SCHEMATIC REVIEW - APPROVED

RE: QUIZNOS SUB
East Judge Perez, Store #7452
2022 E. Judge Perez
Chalmette, LA 70043
(Accepted 8/6/07)

#7452 SCHEMATIC
1542 S.F. BUILD-OUT

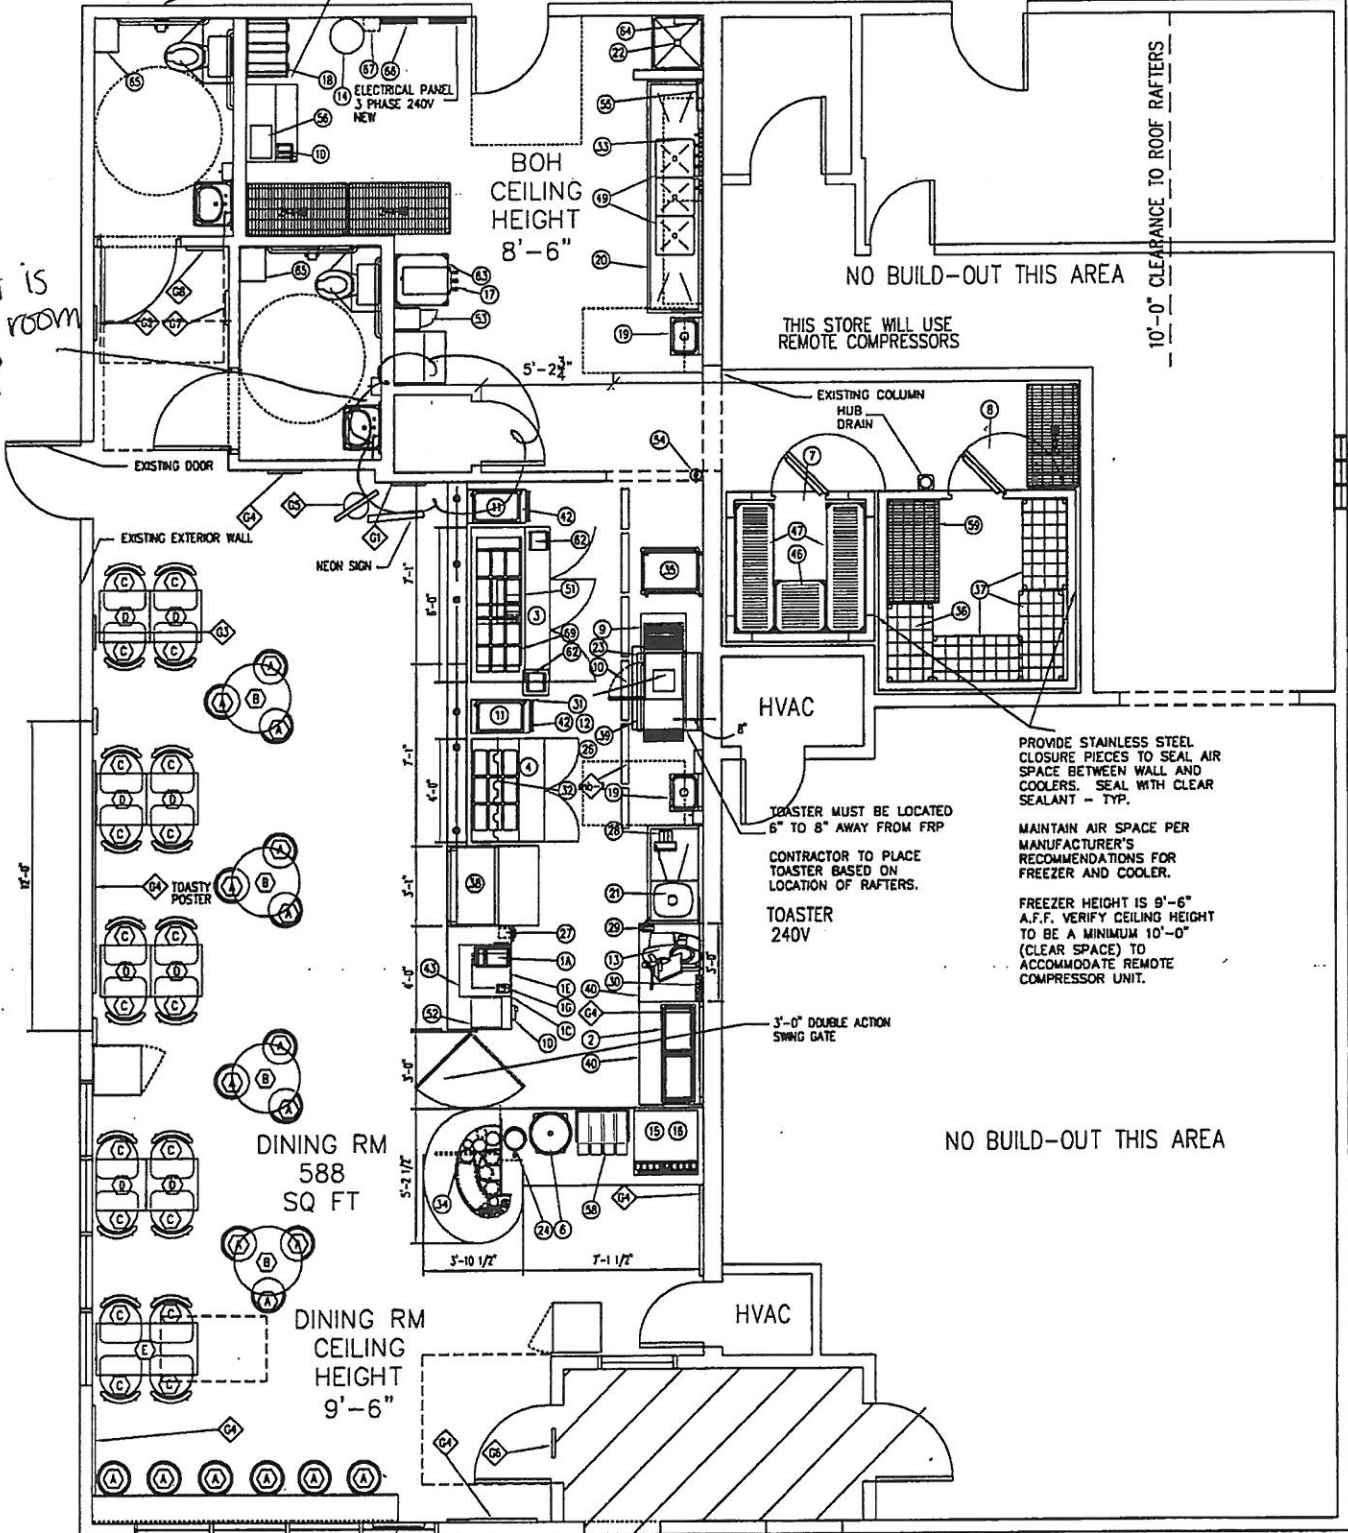
- a. Verify use for room indicated on drawings.

- a. Additional shelving is strongly recommended.

- g. **Remote** compressors noted per the schematic. Verify.
- h. **A 9'-6" high freezer is standard. Please complete the Kolpak worksheet and return it to our office. Construction documents will not be reviewed until the Kolpak worksheet has been received by the design and construction department.**

- i. A **240V** toaster is noted and will be ordered unless otherwise specified. Verify.
- j. **Effective immediately- Place the toaster 6" to 8" away from the FRP to prevent the FRP from melting due to high temperatures from the toaster. ***Verify the clearance of the service area due to the toaster moving out 6" to 8".**

- k. **Effective immediately – two (2) 20-amp circuits are required for the soup station.**
- l. NOTE: The electric panel is noted **NEW** on the schematic. If not noted on CD's then a new electric panel will be ordered regardless. The GE worksheet must be submitted with the CD's.

what is
this room
for?

FREEZER HEIGHT IS 9'-6"
A.F.F. VERIFY CEILING HEIGHT
TO BE A MINIMUM 10'-0"
(CLEAR SPACE) TO
ACCOMMODATE REMOTE
COMPRESSOR UNIT.

TOASTER MUST BE LOCATED
6" TO 8" AWAY FROM FRP
